FEDERAL ENERGY REGULATORY COMMISSION
Washington, D. C. 20426

Project No. 3142-007
Barton Dam Project
City of Ann Arbor

Subject: Run-of-River Deviations

Outflow/Pond Level- December

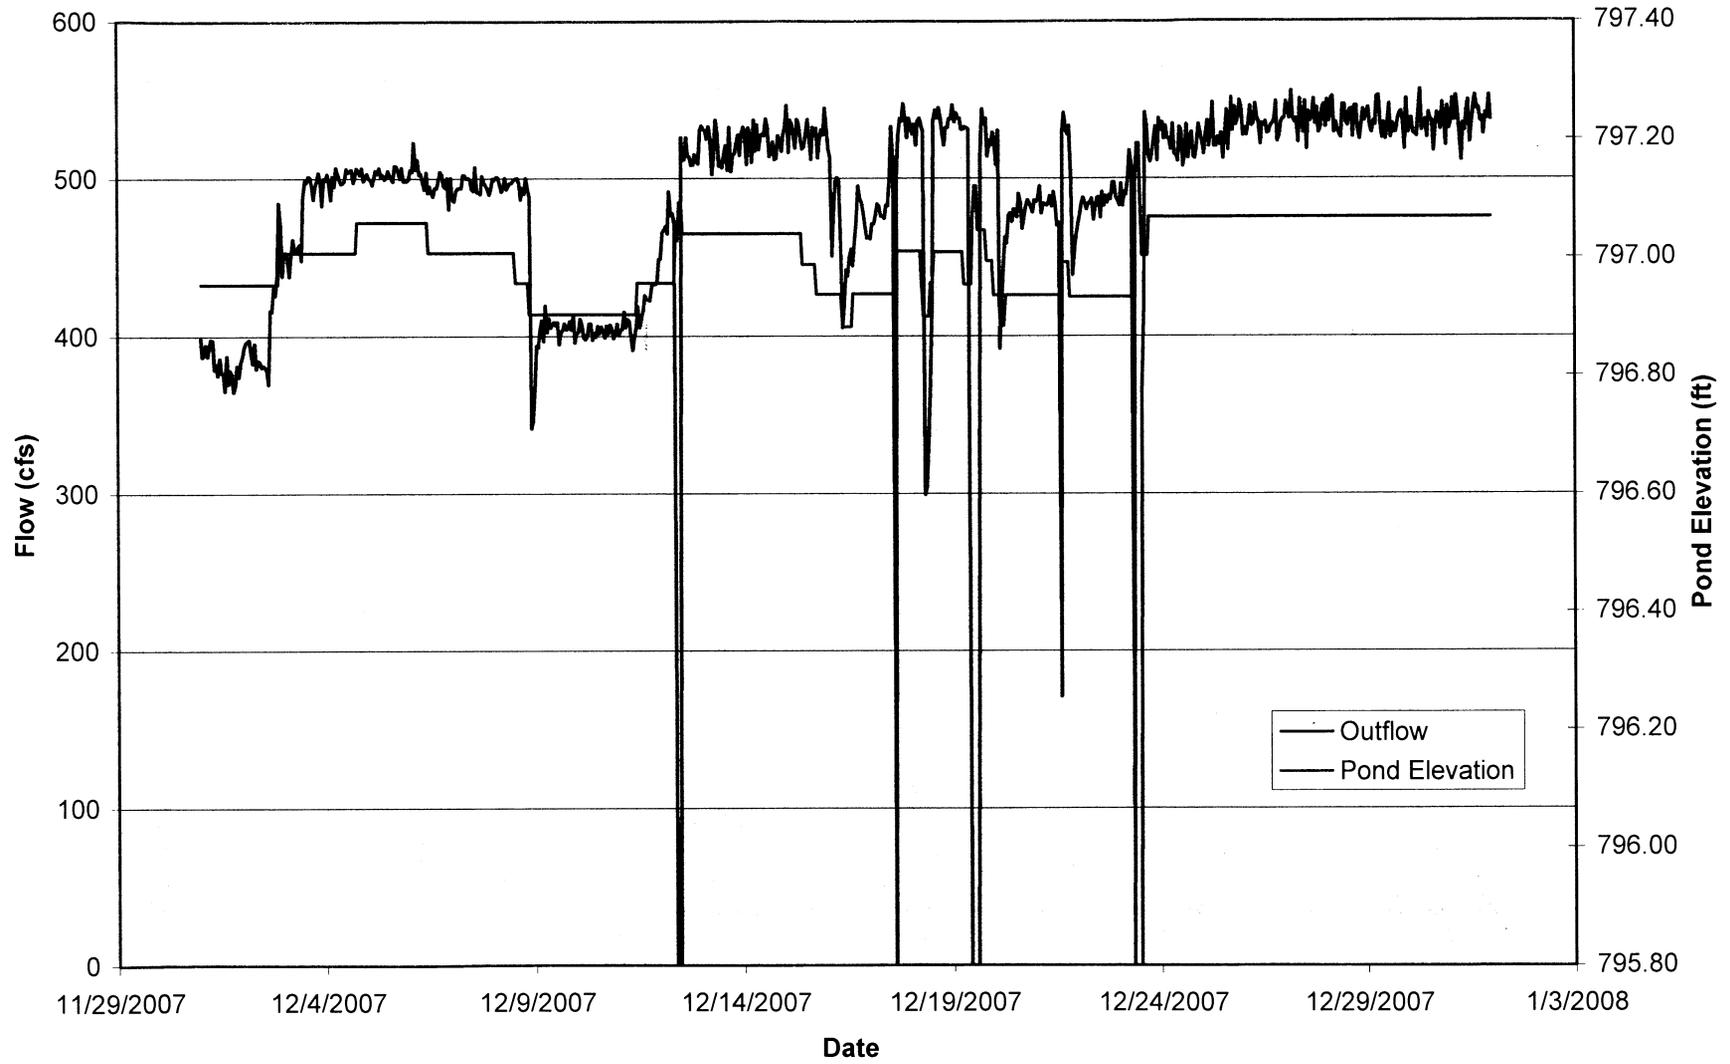
Since gaging stations were not installed at the project, as required by the FWS's article 2 terms and conditions letter, we used the available hourly generation records and the turbine flow rating table provided to determine equivalent flow estimates per hourly generation values. In reviewing this information, we identified specific dates and times when project discharges fluctuated significantly over short periods of time. Specifically, we identified run-of-river deviations on December 8, 18, 20, and 21, 2007; January 2, 4, 6, 10, 16,

30, and 31, 2008; and February 3, 4, 6, 8, and 14, 2008. Appendix A of this letter includes tables and graphs providing more details about these run-of-river deviations.

Based on the data you provided, it is clear that outflow coincides with generation, and frequently this outflow does not represent the natural flow rate entering the impoundment. On a related note, we received a second report of erratic flows occurring below Barton Dam on March 16, 2009. While downstream flows will change over time depending on weather and upstream input, they would not change as rapidly as occurred downstream of Barton Dam. This type of operation does not reflect run-of-river operation and is unacceptable.

In order to resolve the problem, we request that you file a run-of-river plan within 120 days of the date of this letter. The plan should be developed in consultation with the MDNR and FWS. The plan should include provisions for the installation of gaging stations upstream and downstream of the project, pursuant to the FWS's terms and conditions, or concurrence from the FWS on an acceptable alternative. The plan should also include a schedule for installing the gaging stations or alternative measures, and provisions for providing hourly flow records in cubic feet per second (cfs) to the Commission and agencies to verify compliance. In addition, your filing should include documentation of consultation with the MDNR and FWS on your proposed plan, including responses to any specific agency recommendations that are not incorporated into the plan. You should allow a minimum of 30 days for the entities to comment and to make recommendations before filing the plan with the Commission.
